SUNSHINE COAST REGIONAL DISTRICT

Question and Answers #1

Request for Proposal No. 2536504

Garden Bay Treatment Plant Replacement Preliminary Design

Chlorine Treatment System

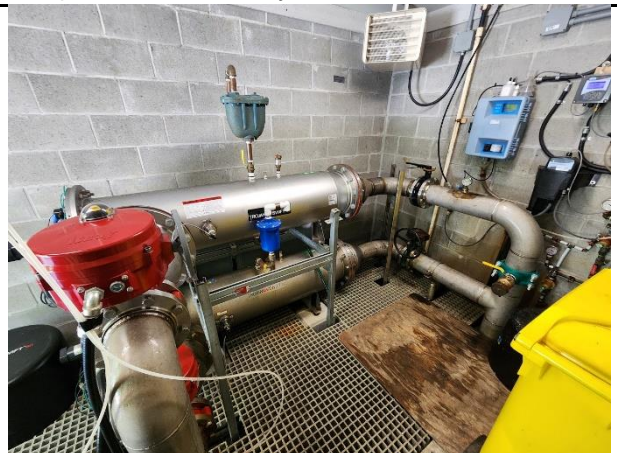
Question: Can you please provide clear photographs of the building, including interior views that show:

- The UV disinfection units.
- The chlorine system.
- The distribution system.

Answer: Yes, please see below.
